Planning/Zoning Application

RE: Site Plan Review for the New Massman Corporate INC at 2005 Venture AV
(Parcel WD-D0076)

Thank you for the revised site plan for the New Massman Corporate INC at 2005 Venture AV. The City of De Pere staff reviewed the site plan on May 10, 2024, and recommended approval, with the following condition that must be addressed prior to submitting a request for occupancy permits:

LANDSCAPE PLAN

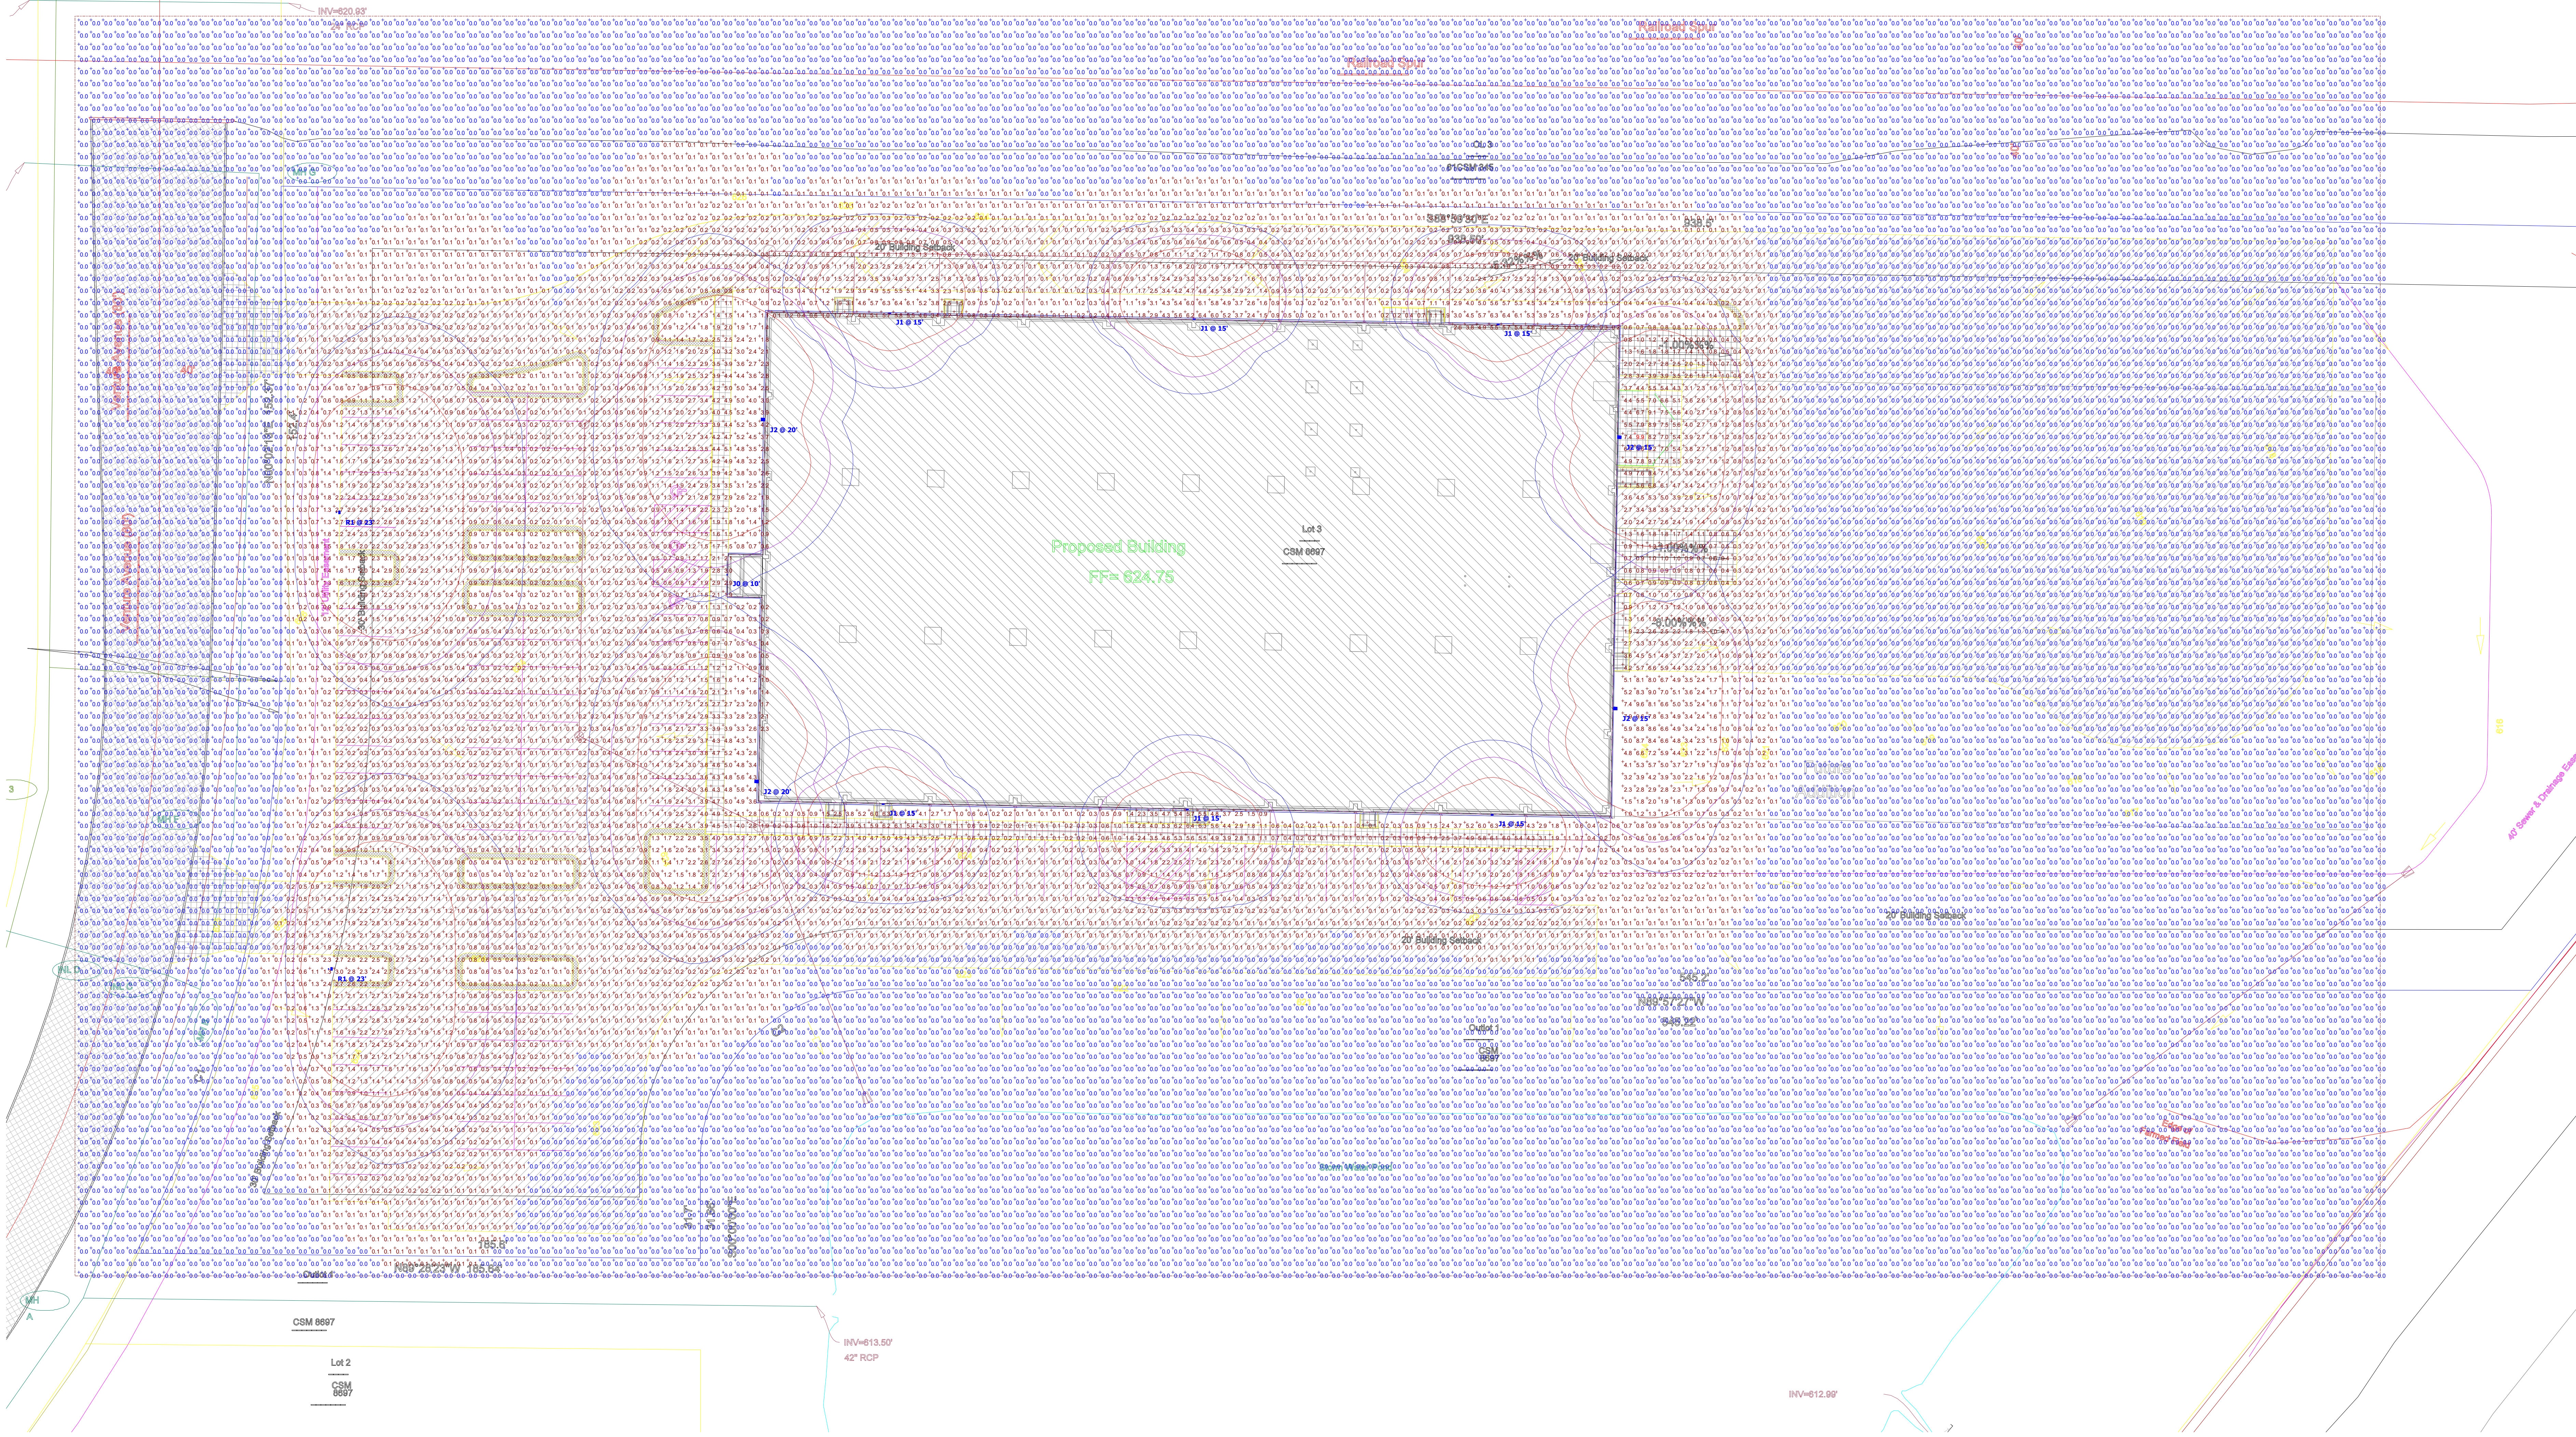
- Trees planted in the city terrace will need to be coordinated and marked by the City Forester. The City Forester will need to be on site when trees are planted to ensure correct procedures are followed. Contact the City Forester prior to installation to schedule dates/times to complete the tasks.

- After landscaping is installed, provide a statement from the landscaper that verifies that all landscaping has been installed according to the approved landscaping plan to minimize delays or violations related to this topic.
